UNITED STATES PATENT AND TRADEMARK OFFICE

10/798,422

Office Action Summary

DETAILED ACTION

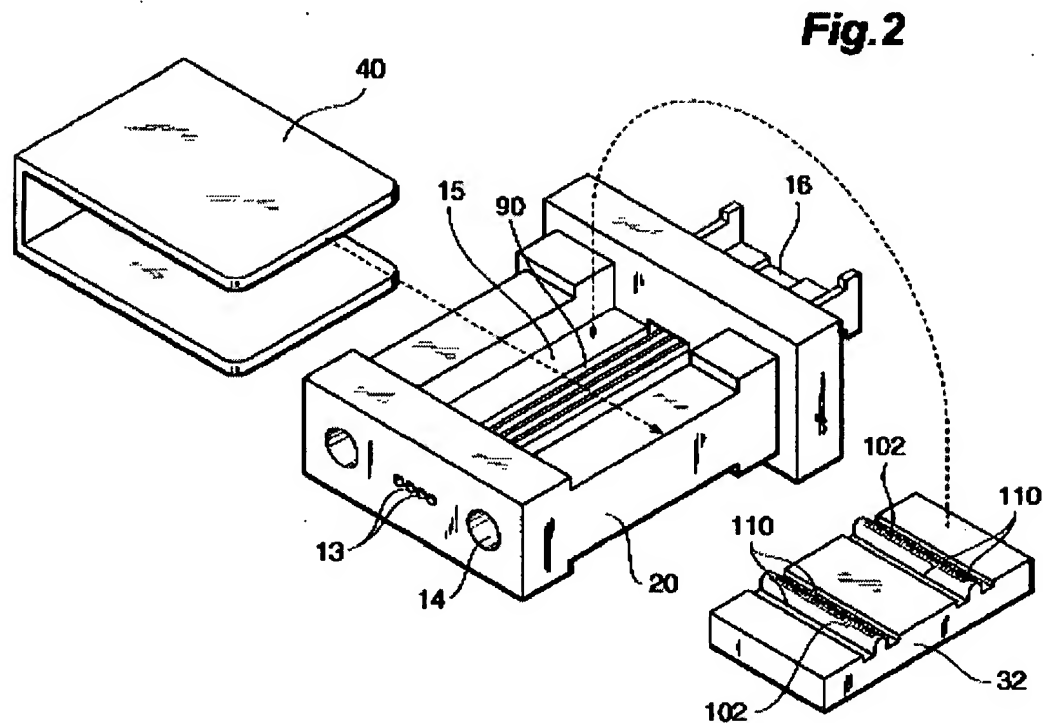
4. **Claims 1-4, 12, and 29 are rejected under 35 U.S.C. 102(b) as being clearly anticipated by Patent No. US 6,377,743 B1 to Ueda et al. ("Ueda").**

In re claim 1, Ueda discloses in Figures 1-5, an optical fiber fixing system for fixing an optical fiber comprising:

a fixing body **20/2** comprising a first groove **90/9**, formed in a top surface thereof, extending in a first direction to support the optical fiber along its axial direction; and

a pressing body **32/3** comprising a protrusion **102/10**, formed on a first surface thereof, a longer part of the protrusion **102/10** extending in a lateral direction, wherein said lateral direction is substantially perpendicular to the direction of the first groove **90/9**, and

the first surface of the pressing body 32/3 faces the first surface of the fixing body 20/2 as is seen in Figures 1 and 3. Figure 2 of Ueda is reproduced below.

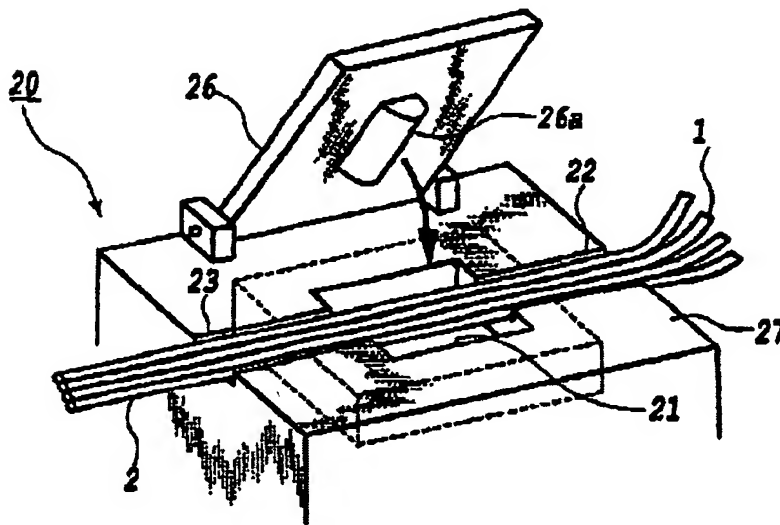
In re claim 1, Hirayama discloses in Figures 2A-2B, an optical fiber fixing system for fixing an optical fiber comprising:

a fixing body 27 comprising a first groove 22/23, formed in a top surface thereof, extending in a first direction to support the optical fiber 1 along its axial direction; and

a pressing body 26 comprising a protrusion 26a, formed on a first surface thereof, a longer part of the protrusion 26a extending in a lateral direction, wherein said lateral direction is substantially perpendicular to the direction of the first groove 22/23, and

wherein the first surface of the pressing body 26 faces the first surface of the fixing body 27 as is apparent from Figure 2A. Figure 2A of Hirayama is reproduced below.

FIG. 1

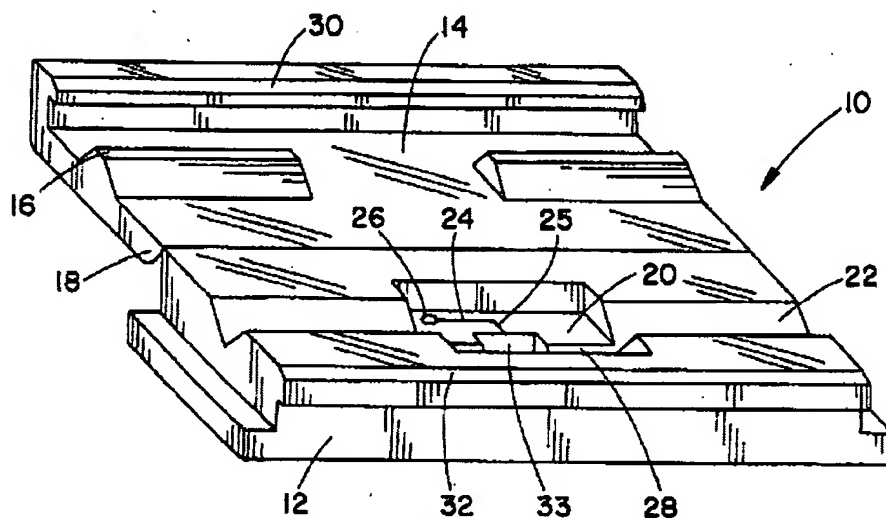
In re claim 32, Harman discloses an optical fiber fixing system (Figures 1-4) for fixing an optical fiber comprising:

a fixing body **12/40/50** comprising a first groove **28** formed in a first surface thereof, and a second groove **22** formed in a second surface thereof, both extending in a first direction to support the optical fiber **37** along its axial direction; and

a pressing body **14/54** comprising a planar clamp portion (i.e., the flat surface surrounding protrusions **16**) facing the first surface of the fixing body **12/40/50**, and a guide portion/protrusion **16** facing the second surface of the fixing body **12/40/50** and comprising two sloped portions configured to interface with the second groove **22** to align the optical fiber therein. Figure 1 of Harman is reproduced below.
